RE: Contract for Alberta Revitalization Infrastructure Phase 1B
Our File Number: A15-0388

RESOLUTION AUTHORIZING CHANGE ORDER NO. 1 FOR ALBERTA REVITALIZATION INFRASTRUCTURE PHASE 1B (A15-0388)

CONTRACT CHANGE ORDER NO. 1

DATE: October 20, 2015
PROJECT: ALBERTA REVITALIZATION INFRASTRUCTURE PROJECT PHASE 1B
TO: RYAN SHIRLEY COMPANY, INC.
(Contractor)

Sheet No.	C8-3
Date	08/11/2010
Drawn By	J. TRAVIS
Checked By	M. B. P.
Scale	AS SHOWN
Project No.	1204
Revision	1

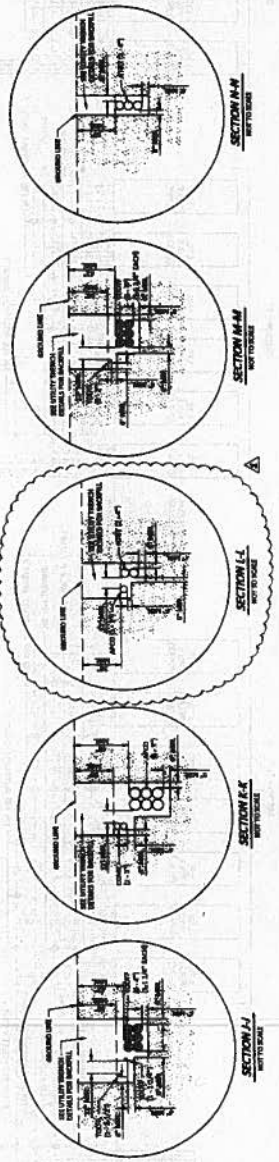
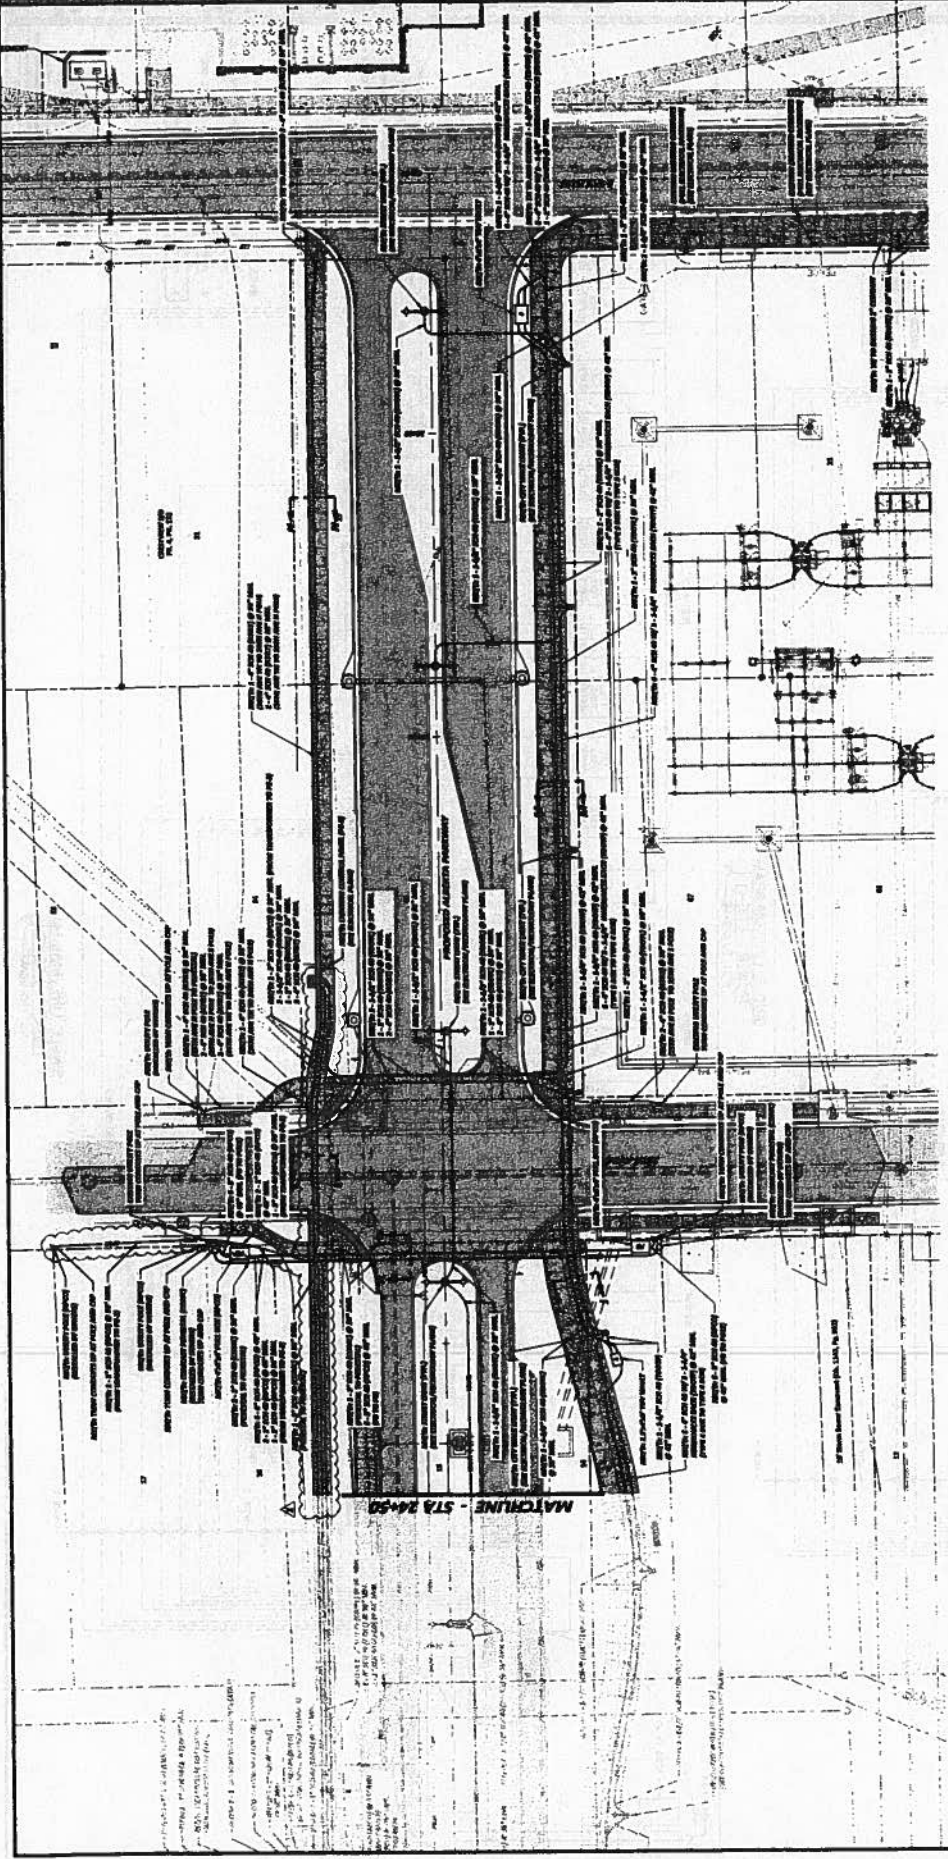
attachments: SEG Electrical Memo Summarizing Changes to Electrical Plan Sheets
Revised Sheets C8.1, C8.2, C8.3, E1.4, E2.0, and E2.1
Supplemental Sketch Highlighting Conduit Changes

Sheet No. **E1.4**

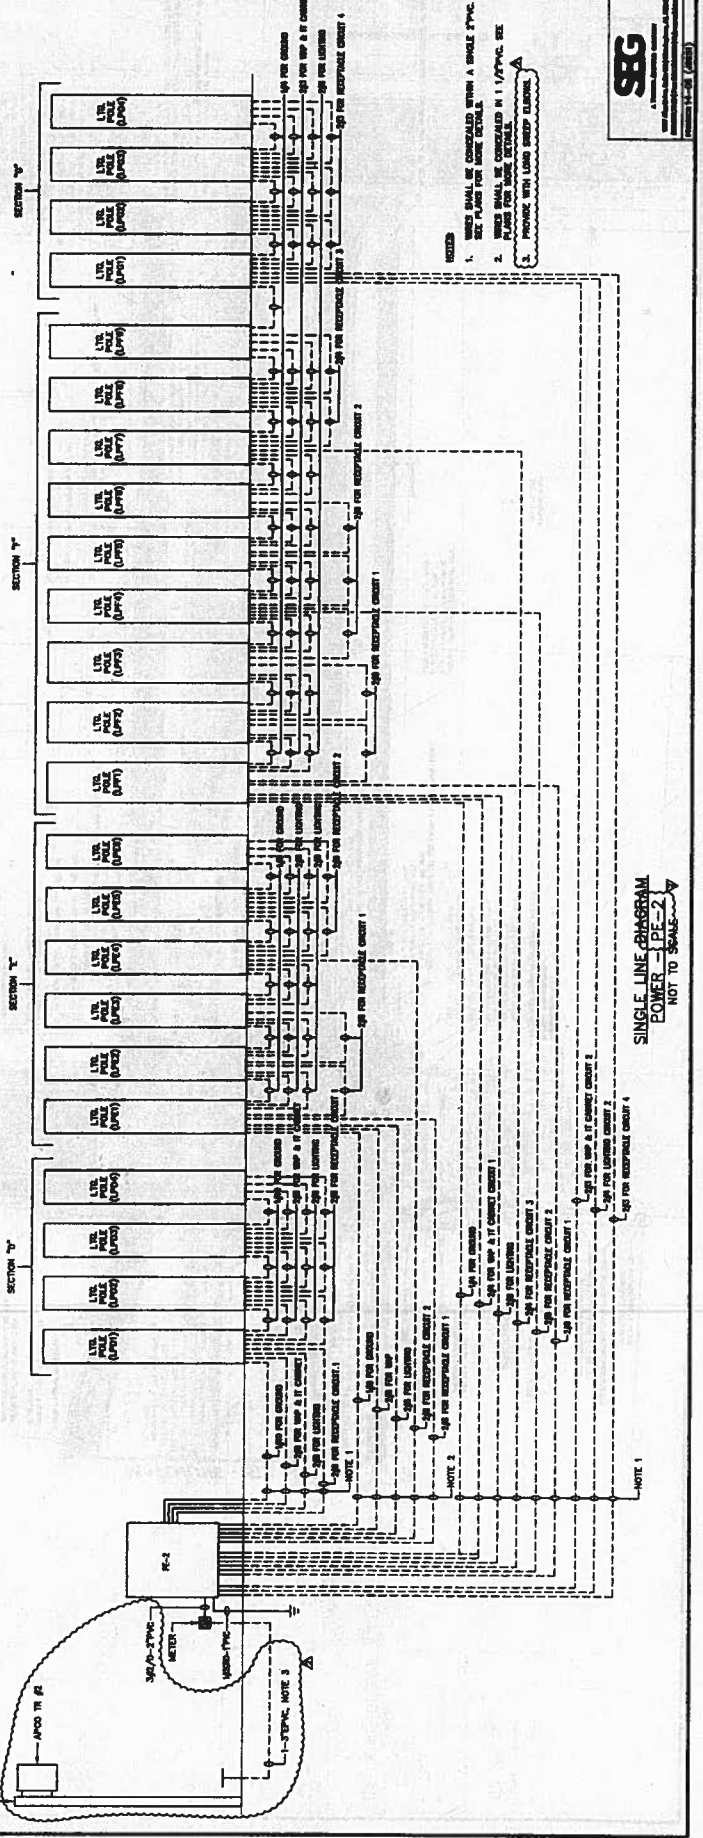
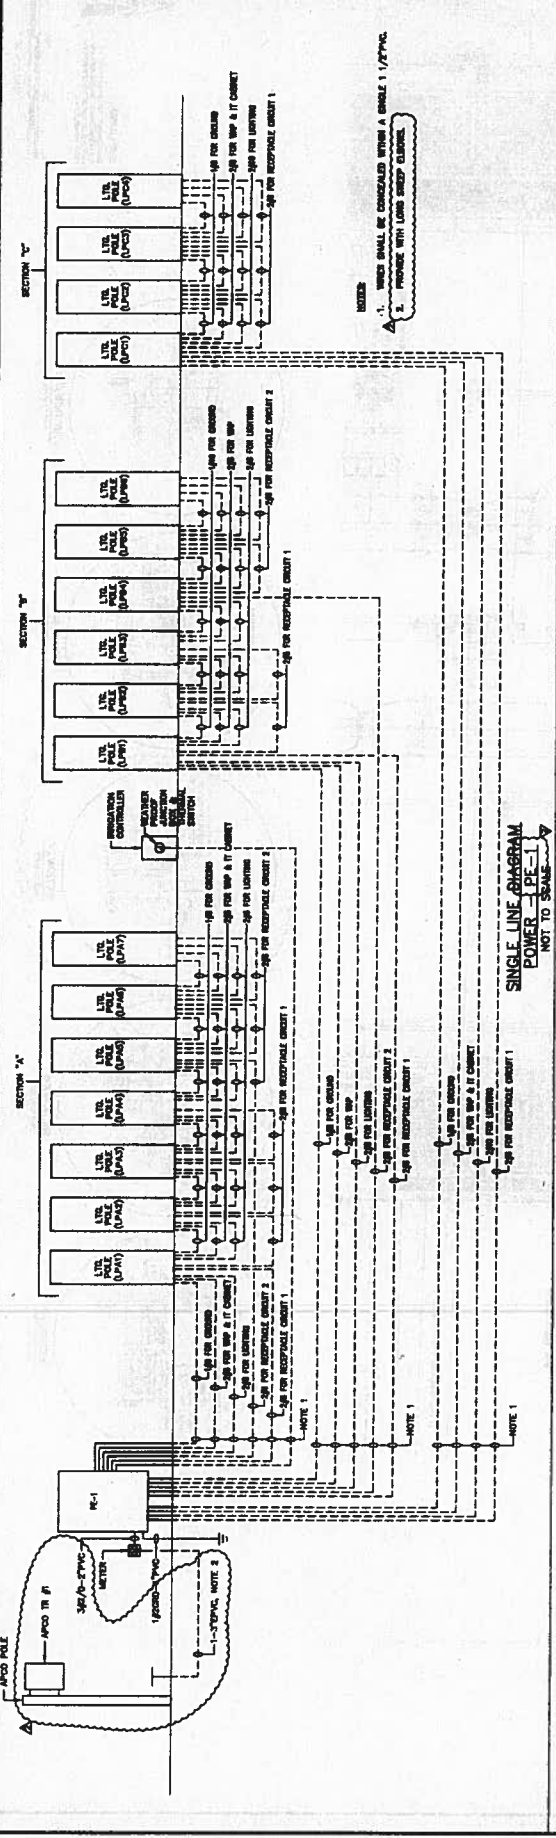
Sheet E-1.4

4. Revised run for 3" schedule 40 PVC conduits from utility pole. Now Conduit runs from utility transformer pole to utility meter at both PE-1 and PE-2. Contractor shall refer to Civil Engineering plans for exact location of utility transformer poles.

5. Added note to provide 3" PVC conduit from utility transformer pole with long sweep bends.

E2.0

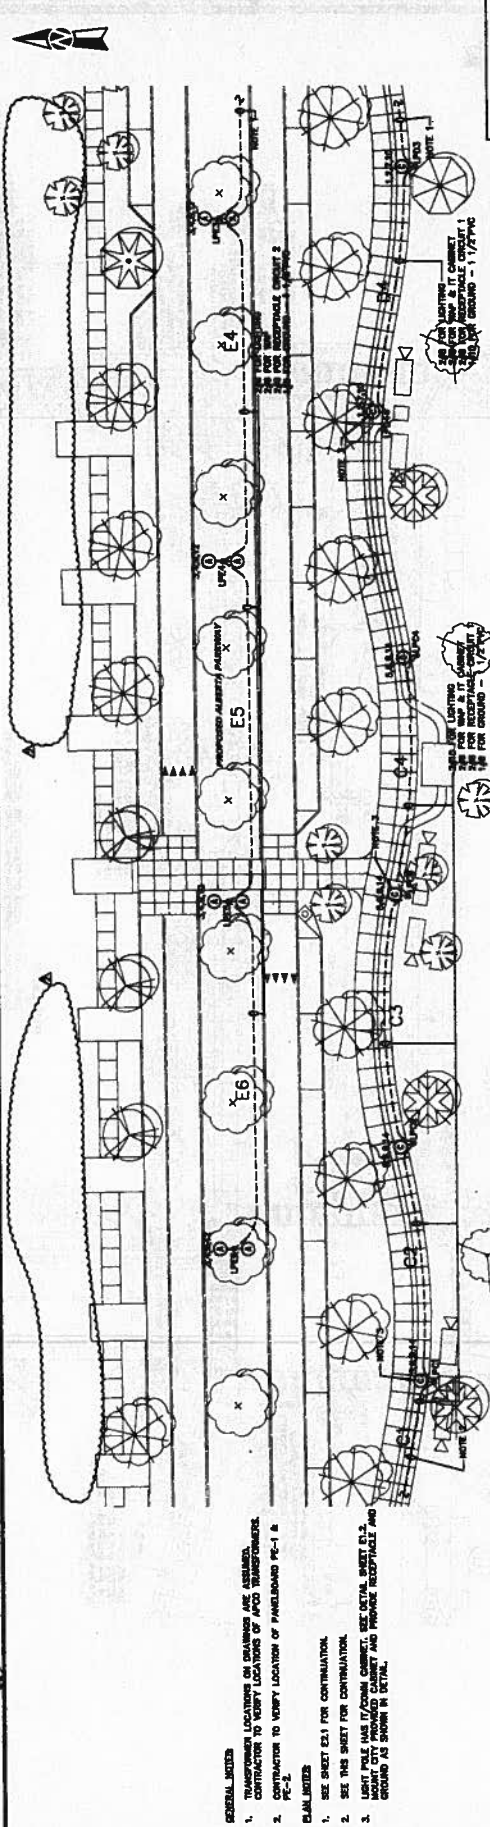
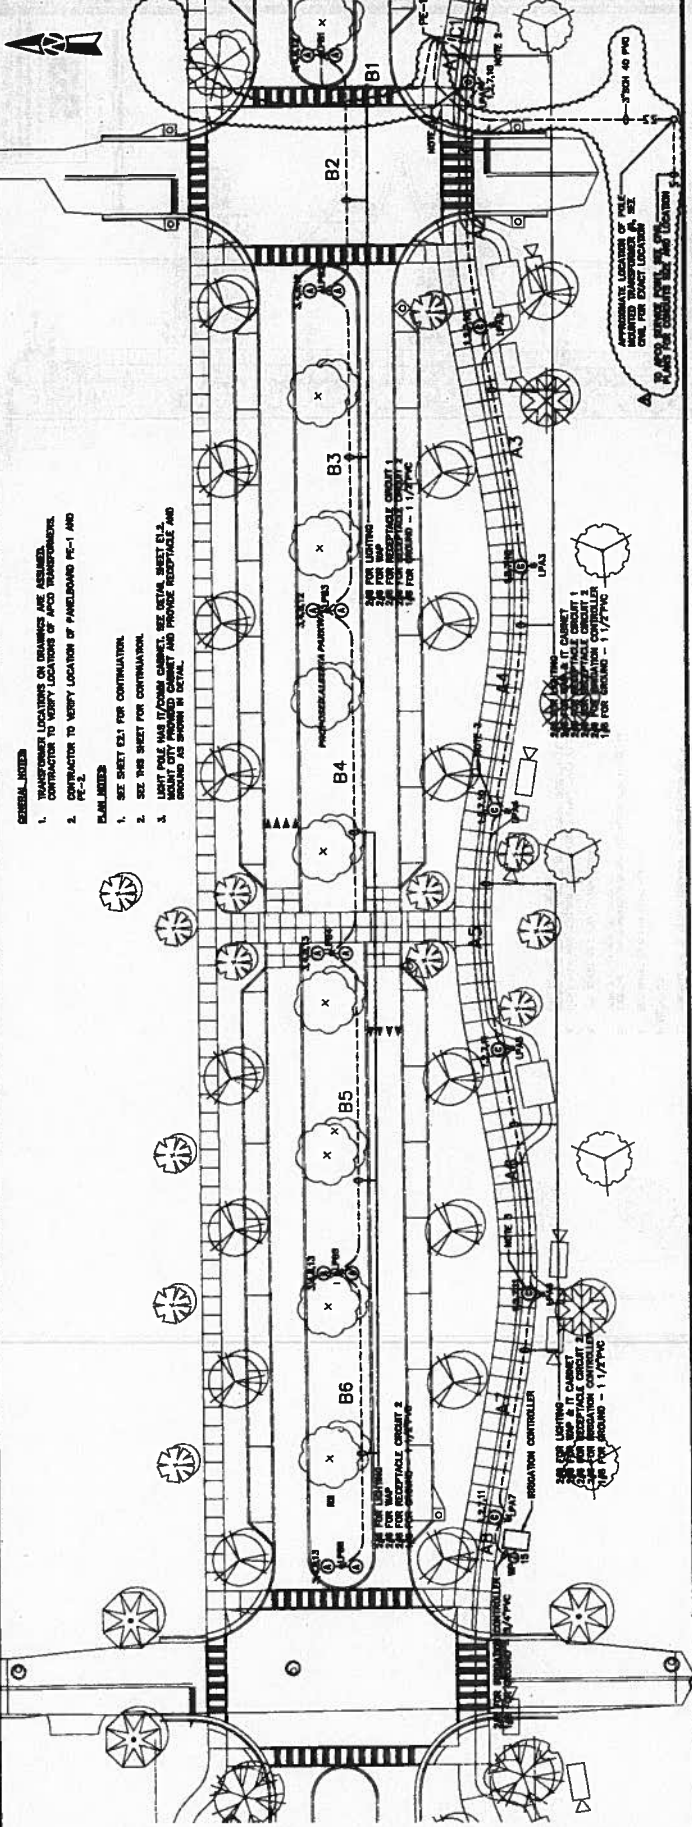
Sheet E2.0

1. Deleted Pad mounted transformer and associated secondary conductors and conduit from TR#1 to PE-1 and from TR#2 to PE-1. Pad mounted transformers have been deleted from scope of work of electrical E series documents.
2. Added 3" Schedule 40 PVC conduit from new location of APCO transformer pole to panel PE-1. Contractor shall refer to Civil Engineering plans for exact pole location and routing.

Sheet E2.1

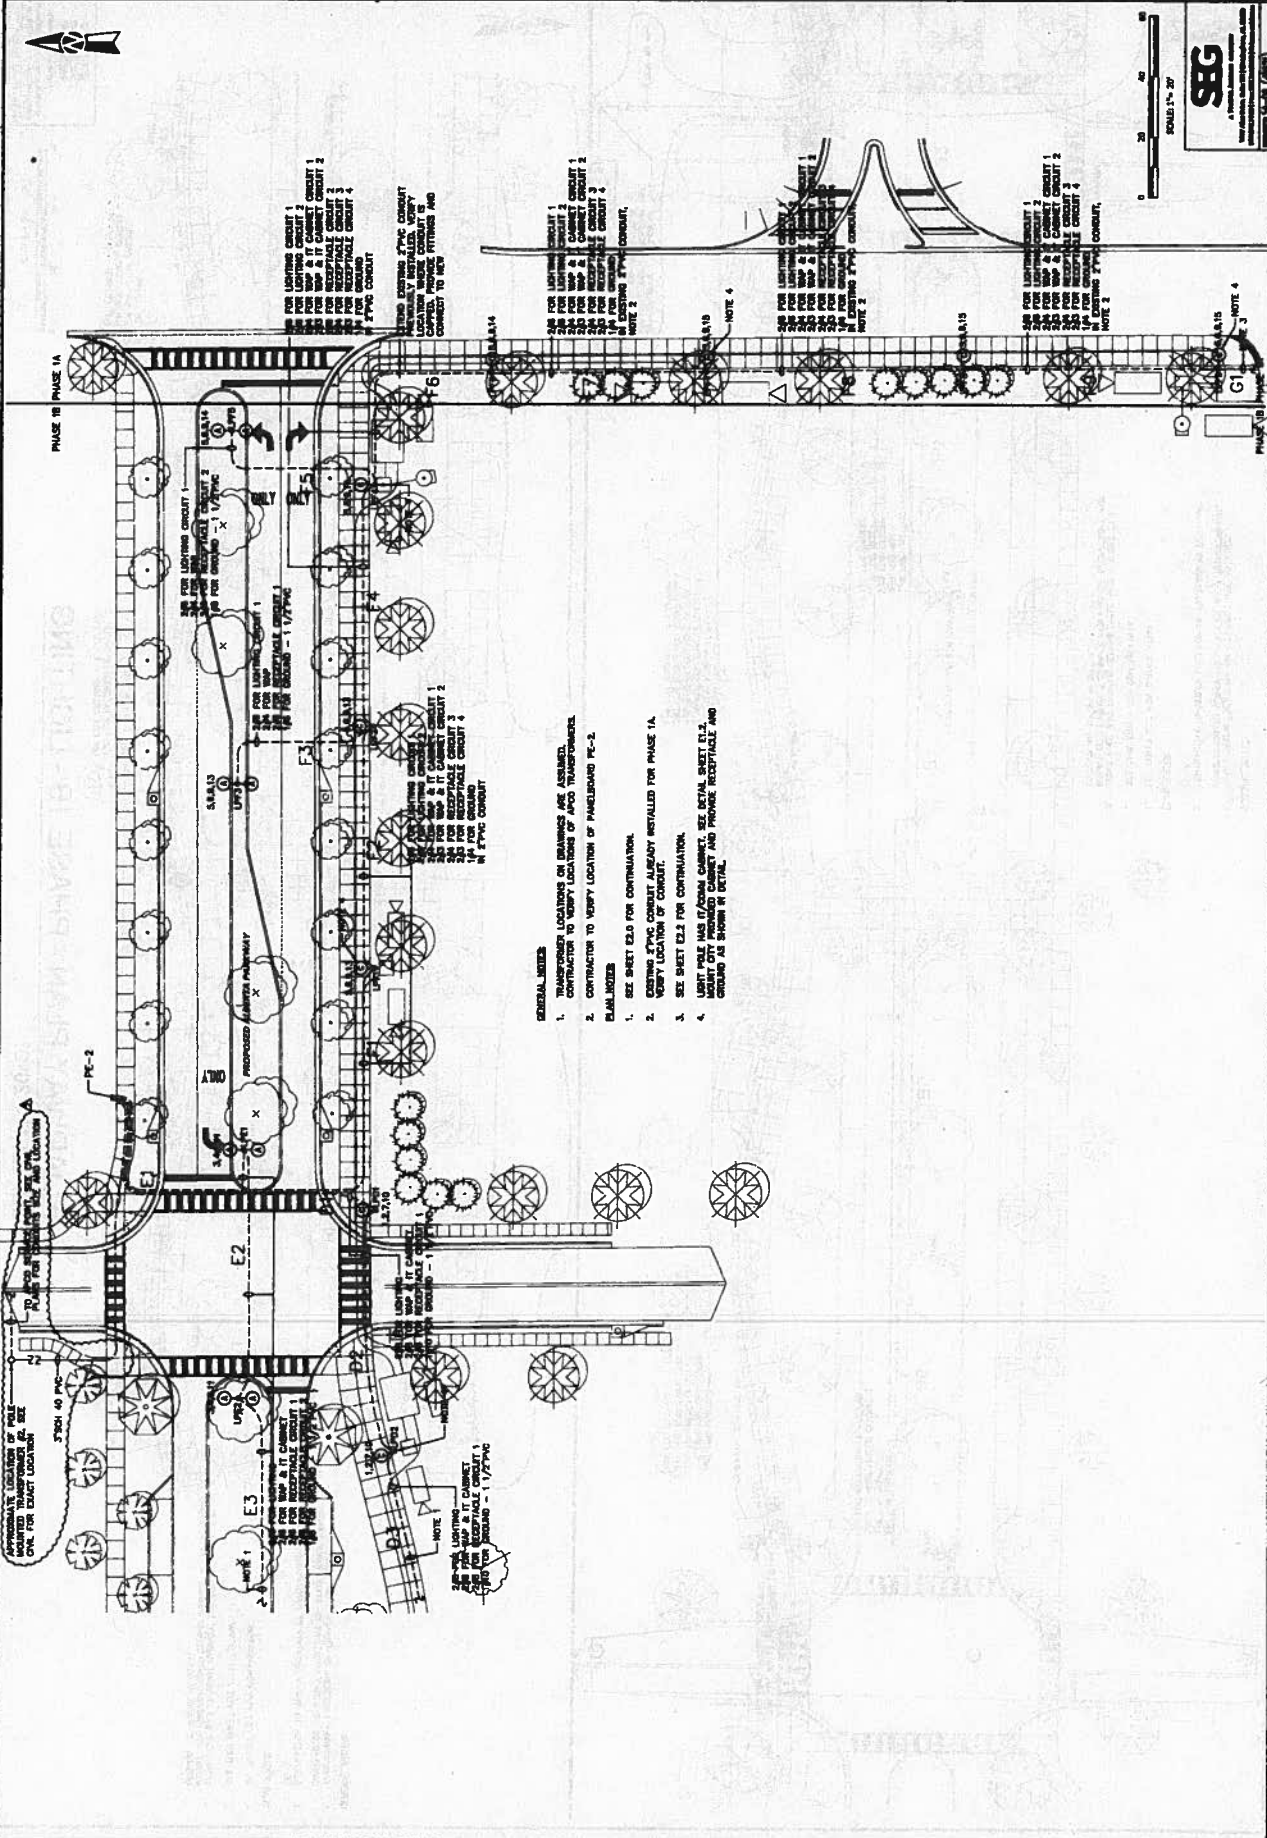
1. Deleted conductor and conduit runs from panel PE-2 to APCO pad mounted transformer TR#2 deleted from scope of work.
2. Added 3" schedule 40PVC conduit from new location of APCO transformer pole to panel PE-2. Contractor shall refer to Civil Engineering plans for exact pole location and routing.

YALA
FIELD DWG. 1 of 2
8/6/15
[Signature]

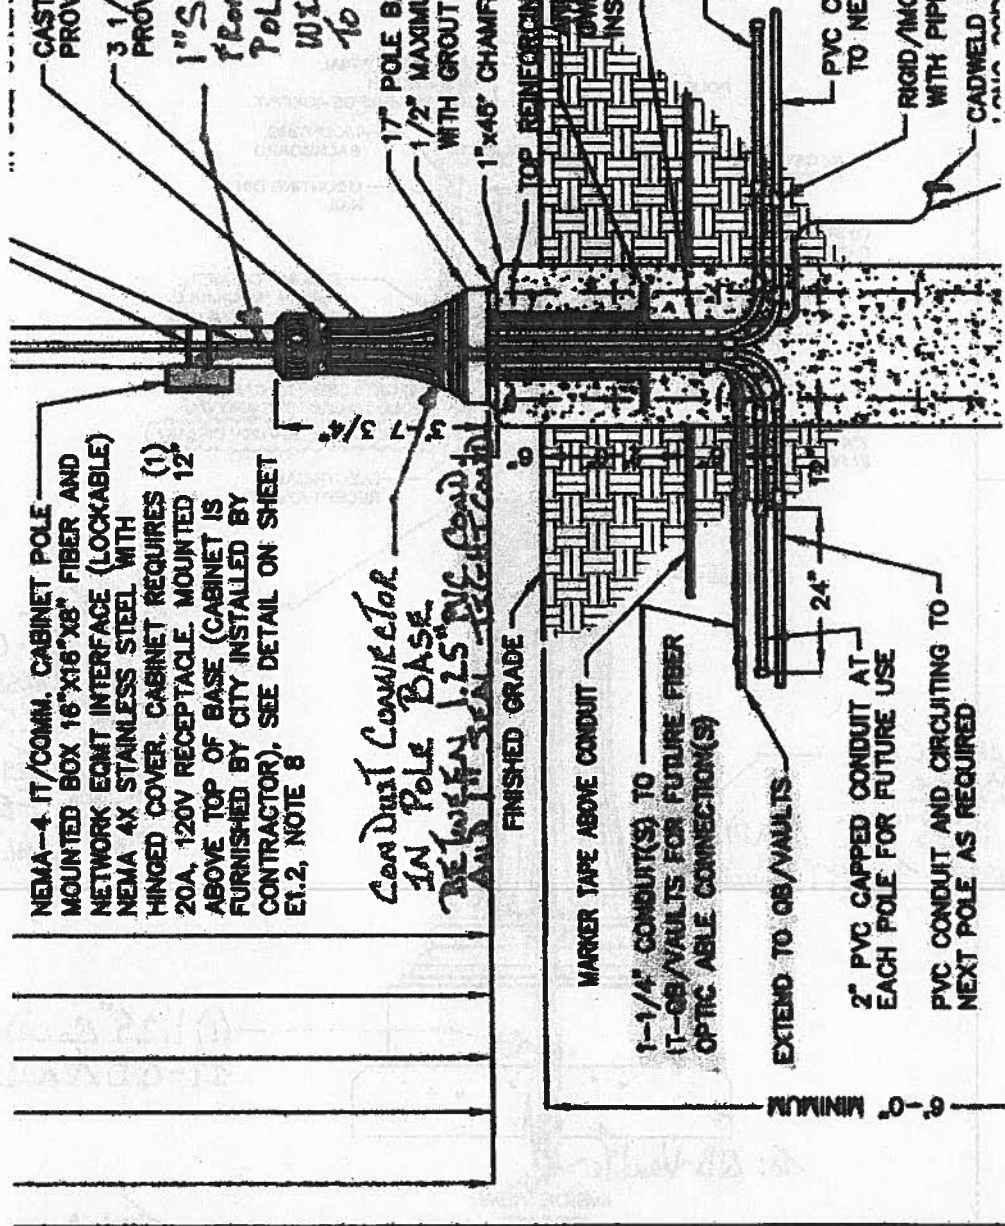
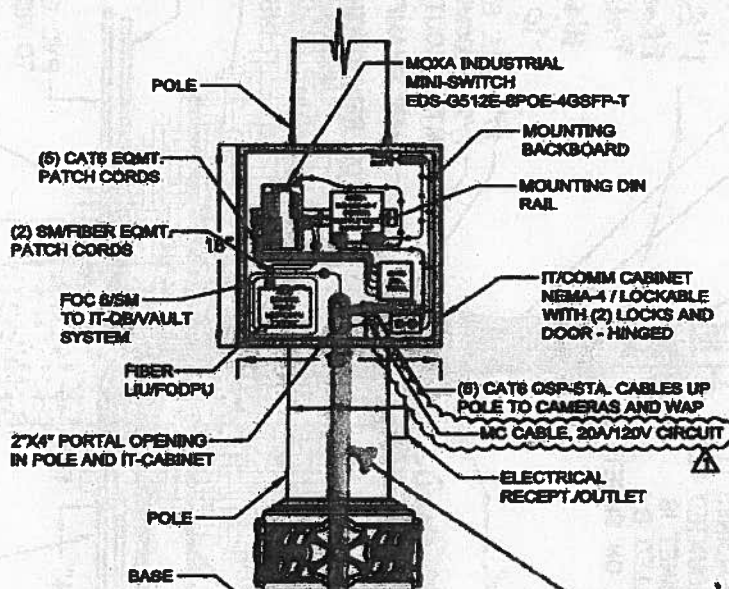
It was discussed and requested that the Contractor provide (1) 1" Seal Tight Conduit from the Pole Base to the IT-Cabinet and connected to the 1.25" PVC Conduit (Which is run to the Comm. QB-Vaults) in the Base with a connector. The 1.25" conduit in the base shall be connected to the 1" seal tight between the pole base and the IT-Cabinets. Also there shall be a pull cord from the vaults to the IT-Cabinets making a continuous pull for the fiber cables.

CONDUIT CONNECTOR
IN POLE BASE
BETWEEN 1.25" PVC CONDUIT
AND 1" SEAL TIGHT CONDUIT.

1" SEAL TIGHT Conduit
From IT-CABINET To
POLE BASE CONNECTION
WITH 1.25" PVC Conduit
To VAULTS. PLACE Pull
CORD FROM IT-CAB.'S
To VAULTS.
